VALUE ENGINEERING WORKSHOP

WIDENING US 441 – FARGO TO PEARSON PROJECTS EDS 441 (41, 46, 48, & 49) Clinch & Atkinson Counties, Georgia

VALUE ENGINEERING TEAM STUDY

PROPOSAL NUMBER:	SB-1.0
PAGE NUMBER:	1 of 3

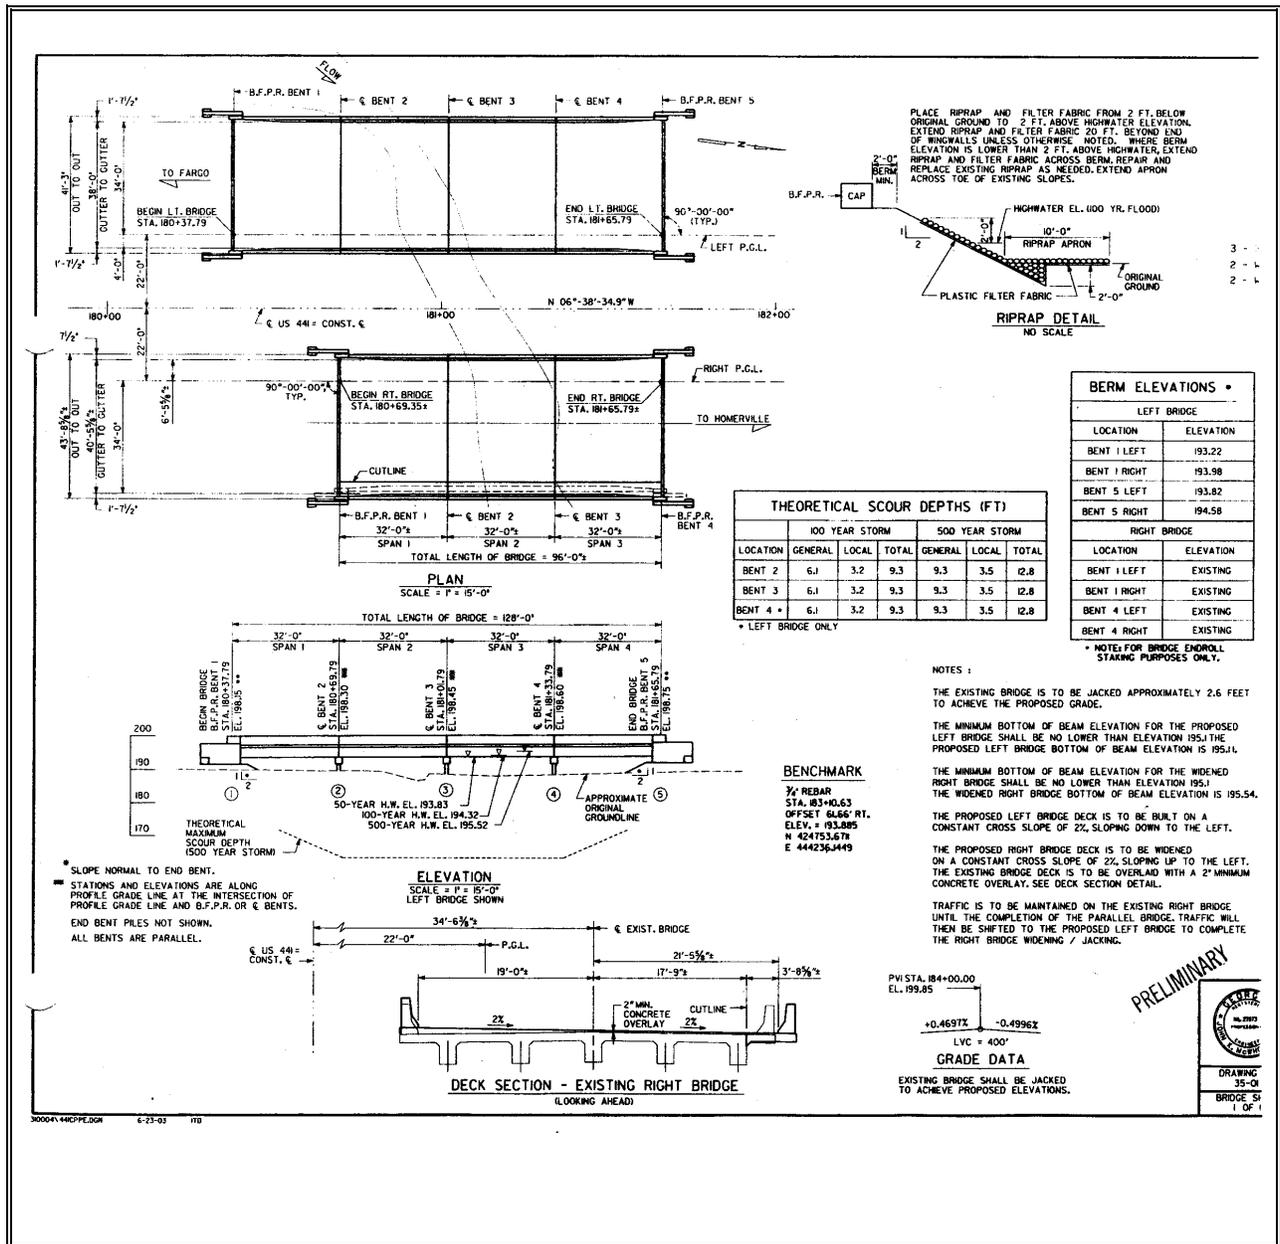
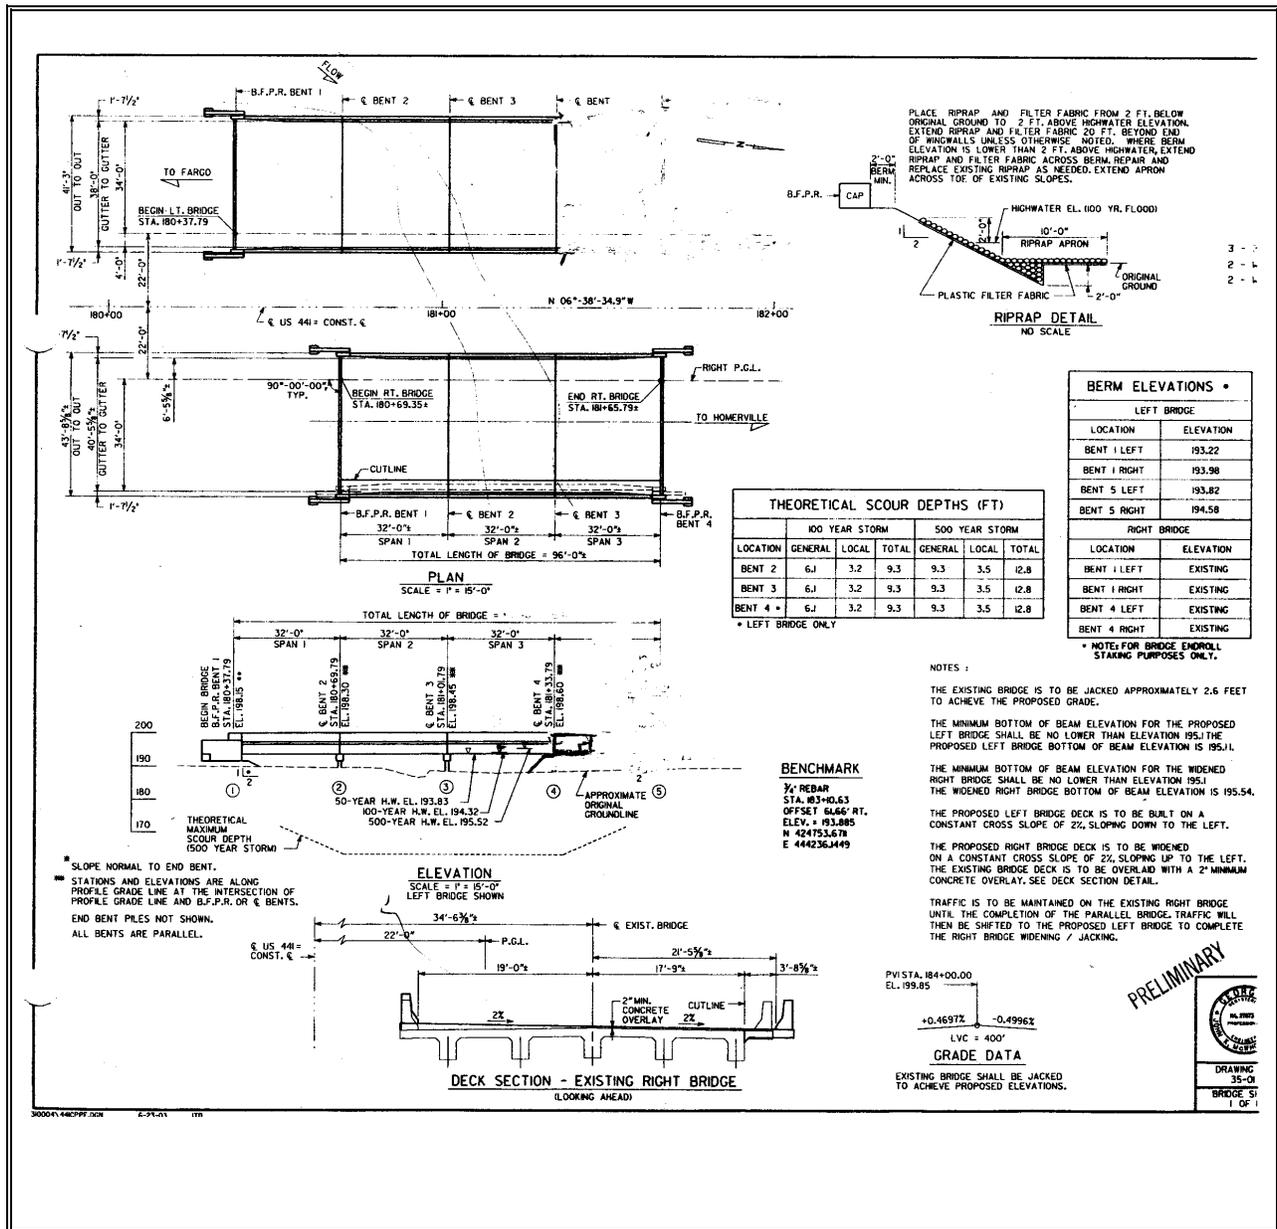
PROPOSAL DESCRIPTION: SWEETGUM BRIDGE (41) - REDUCE LEFT
BRIDGE BY ONE SPAN.

ORIGINAL DESIGN: The original design proposes the addition of a 128'-0" by 41'-3" Southbound left bridge with end station 181+65.79 to align with the proposed in-situ bridge, to be widened.

PROPOSED CHANGE: The proposed change recommends eliminating the last span on the left bridge and shortening the length of the bridge by 32'-0" by bringing the end station to 181+33.79.

Hydraulically a smaller opening.

Backwater increase.

PROPOSAL NUMBER:	SB-3.0
PAGE NUMBER:	1 of 5

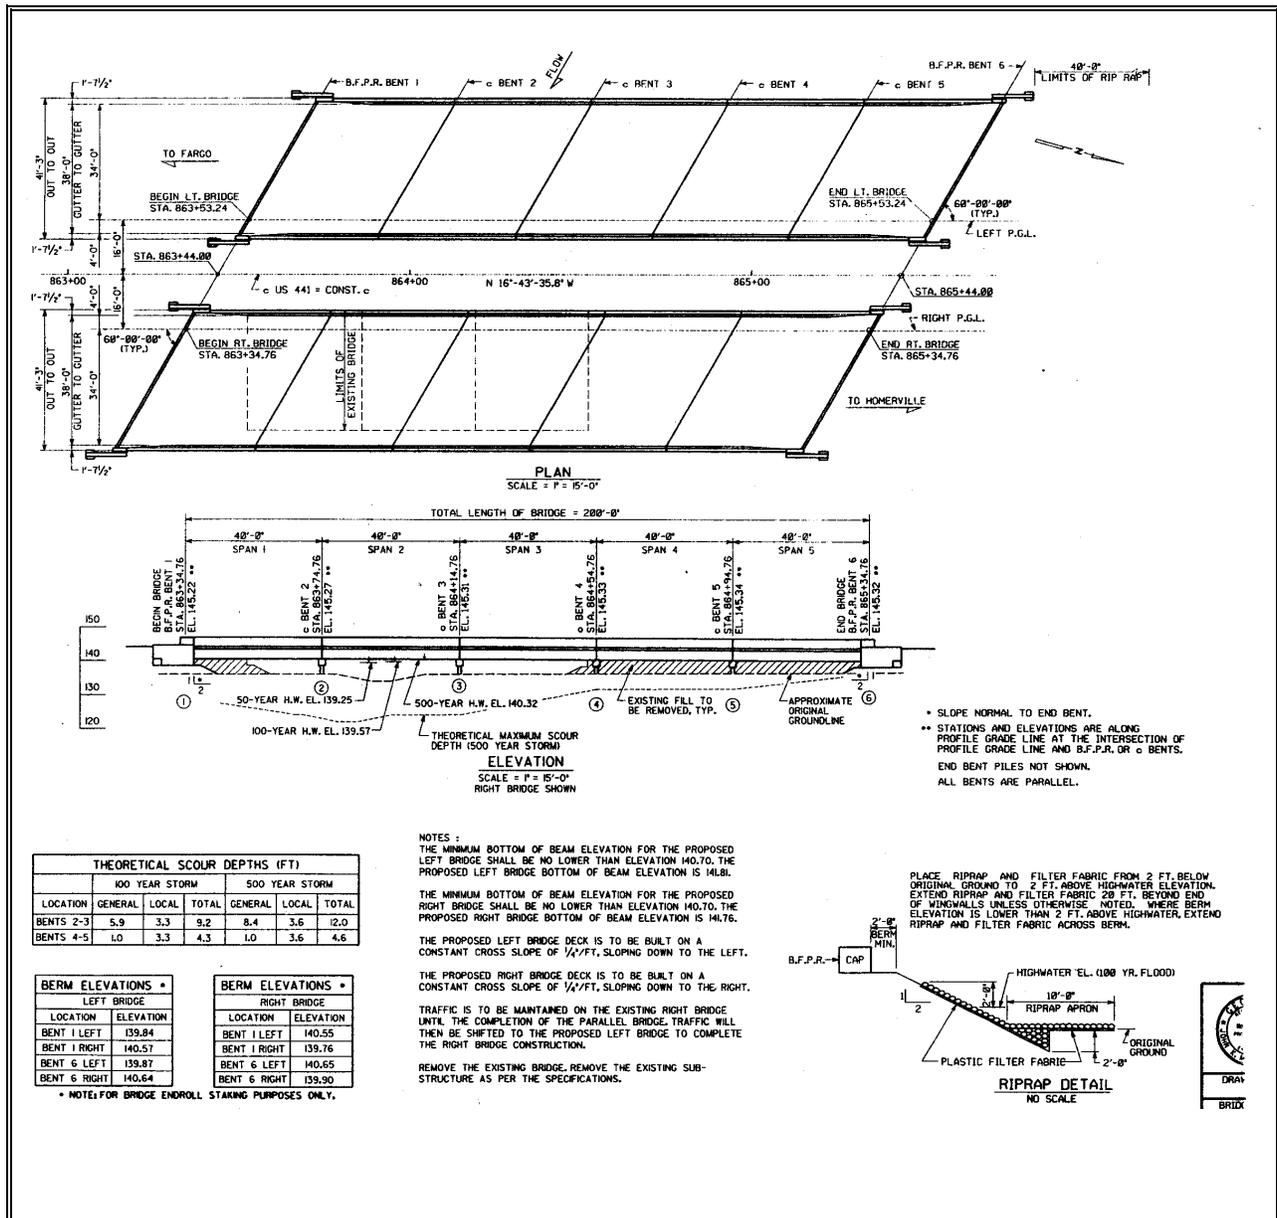
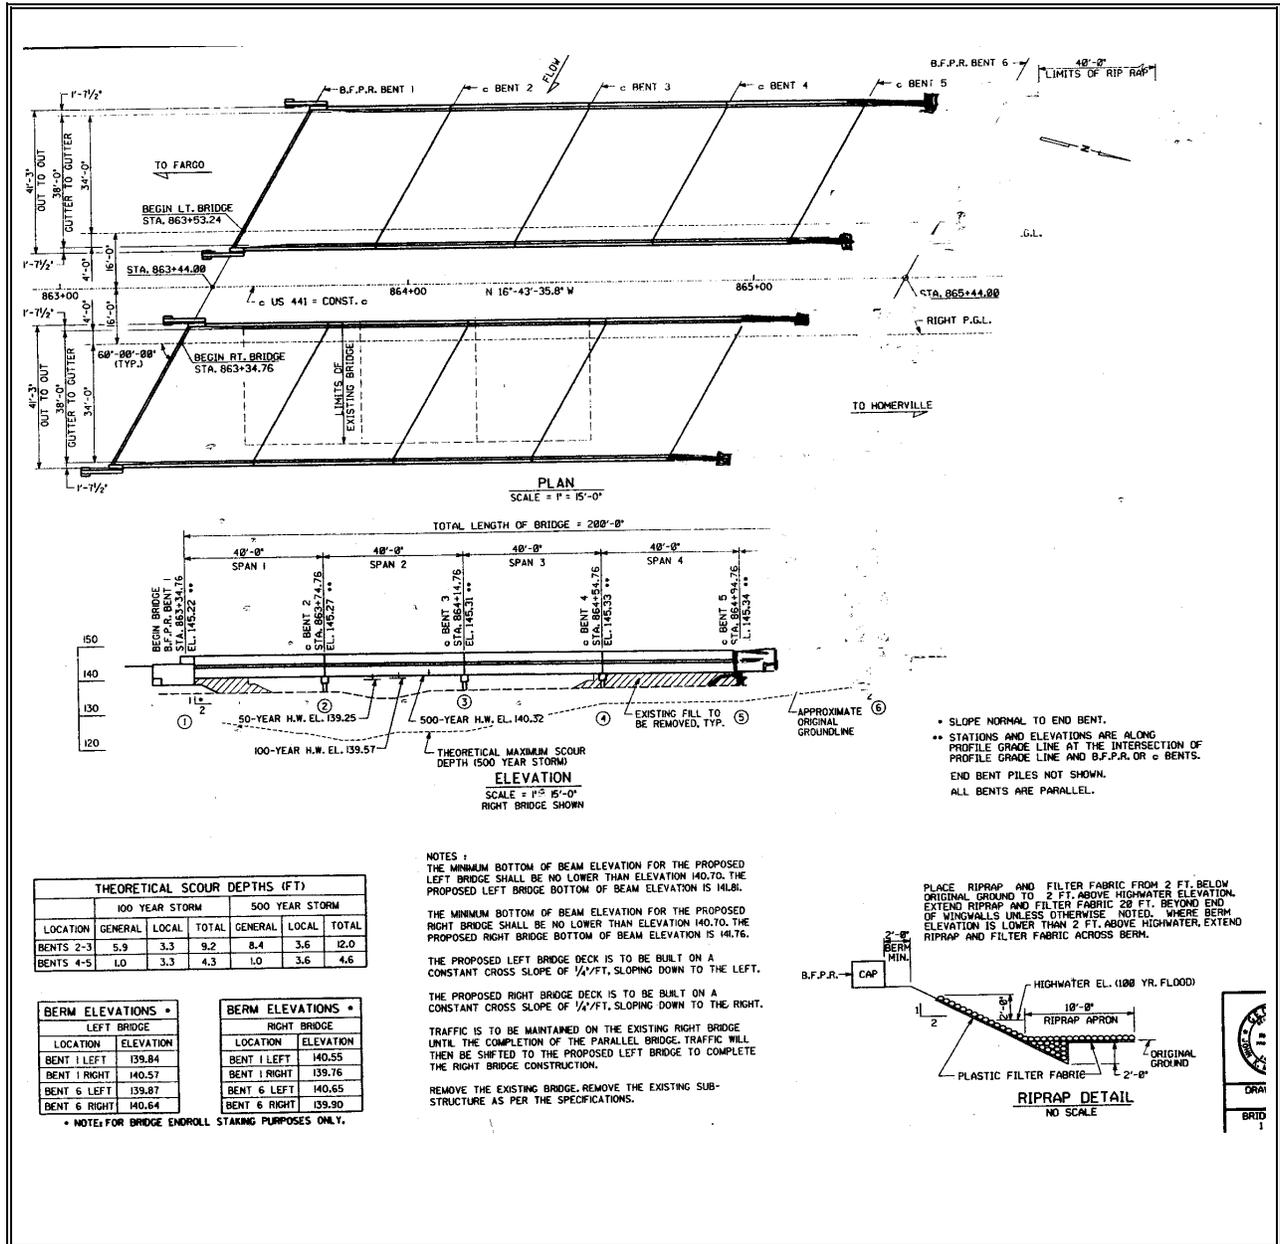
PROPOSAL DESCRIPTION: JONES CREEK BRIDGE (48) - REDUCE BOTH
LEFT & RIGHT BRIDGE BY ONE SPAN.

ORIGINAL DESIGN: The original design proposes the replacement and addition of dual 200'-0" by 41'-3" North & South Bound bridges with begin stations 863+44.00 and end station 865+44.00.

PROPOSED CHANGE: The proposed change recommends eliminating the excess end span as designed on both bridges and shortening the length of the bridges by 40'-0". The begin bridge station is 863+44.00 and the end bridge station is 865+04.

Hydraulically a smaller opening.

Backwater increase.

PROPOSAL NUMBER:	SB-4.0
PAGE NUMBER:	1 of 5

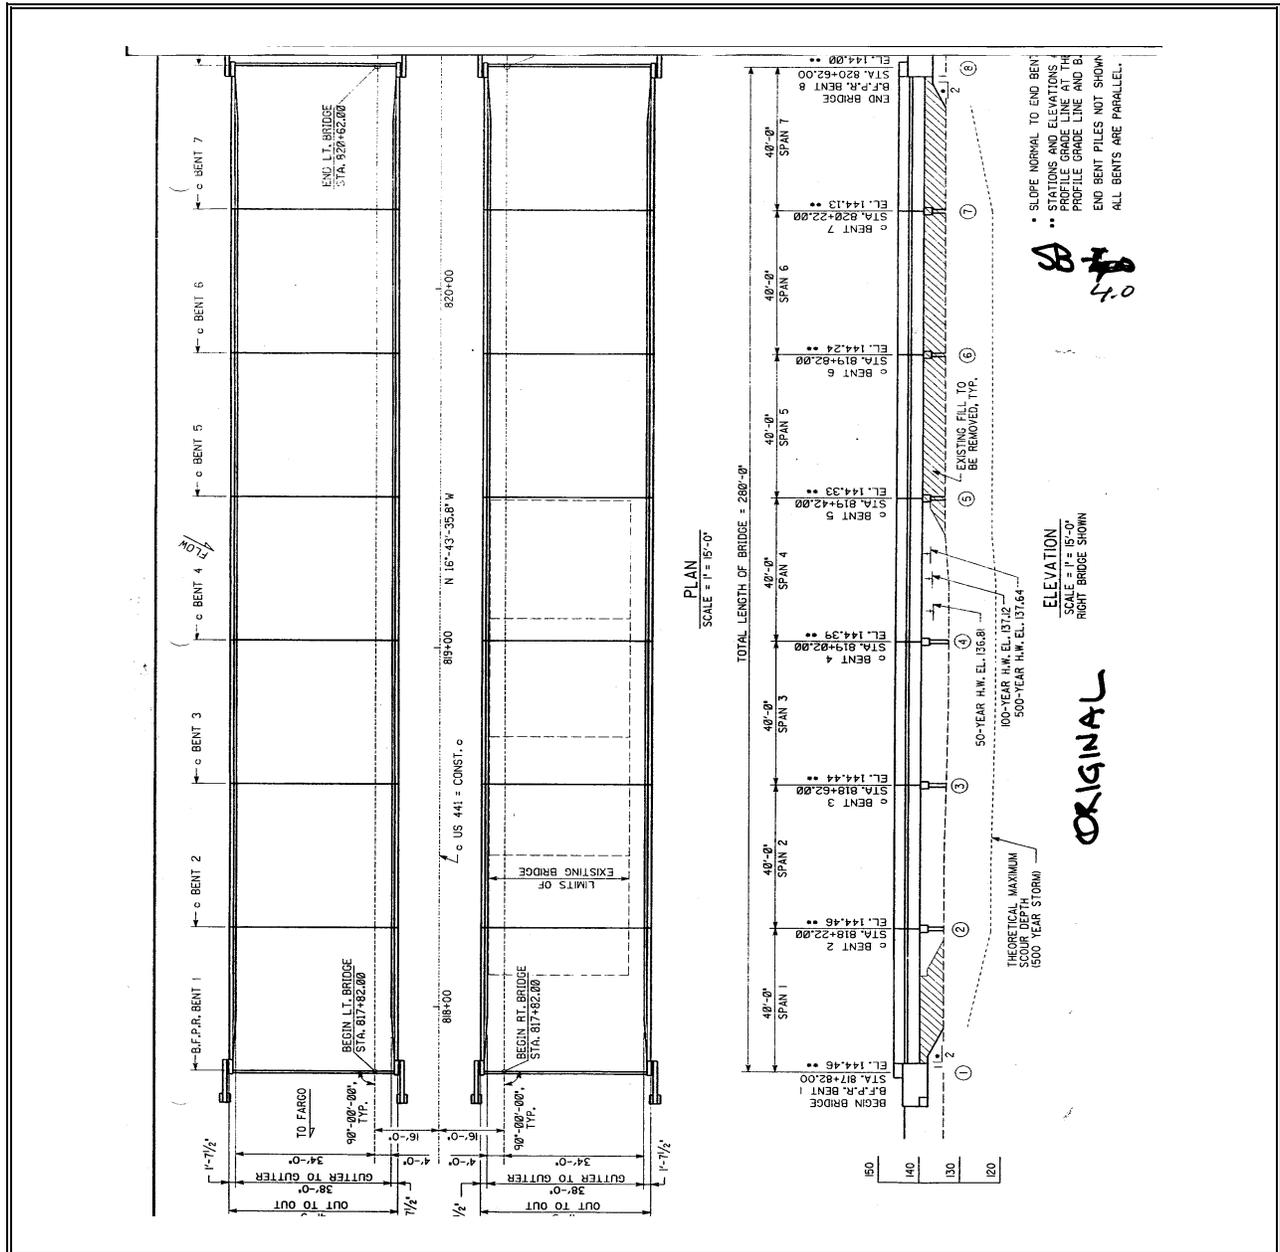
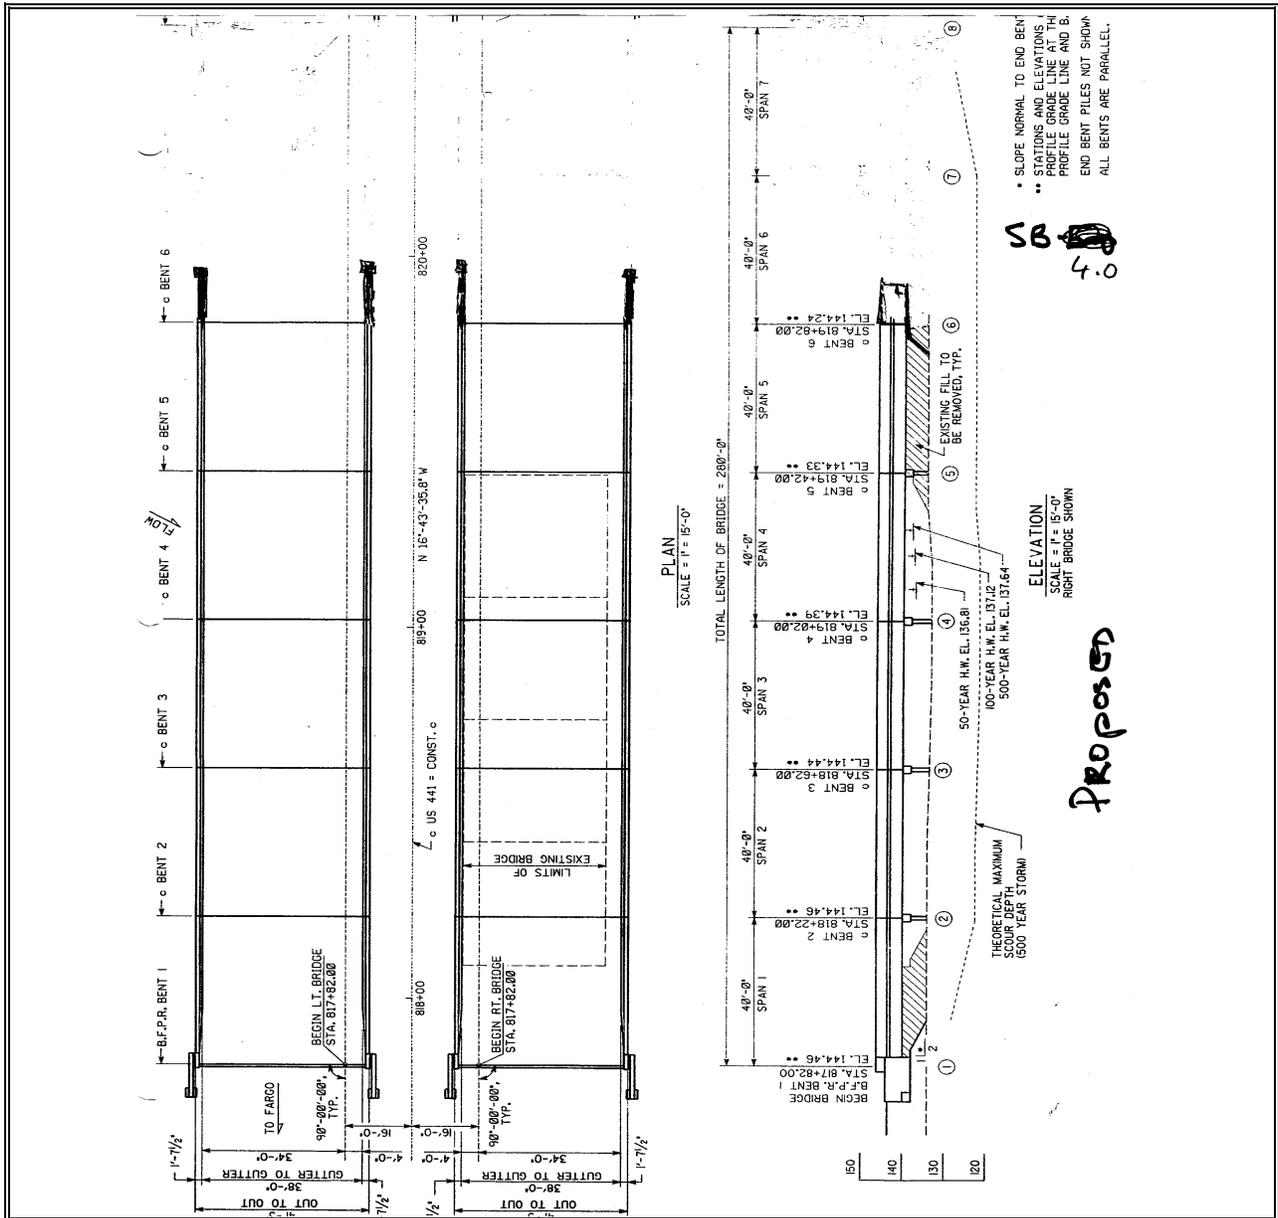
PROPOSAL DESCRIPTION: CAMP BRANCH BRIDGE (48) - REDUCE BOTH LEFT & RIGHT BRIDGE BY TWO SPANS.

ORIGINAL DESIGN: The original design proposes the replacement and addition of dual 280'-0" by 41'-3" North & South Bound bridges with begin stations 817+82.00 and end station 820+62.00.

PROPOSED CHANGE: The proposed change recommends eliminating the not needed end spans 6 & 7 as designed on both bridges and shortening the length of the bridges by 80'-0". The new begin bridge station is 817+82.00 and the end bridge station is 819+82.00.

Hydraulically a smaller opening.

Backwater increase.
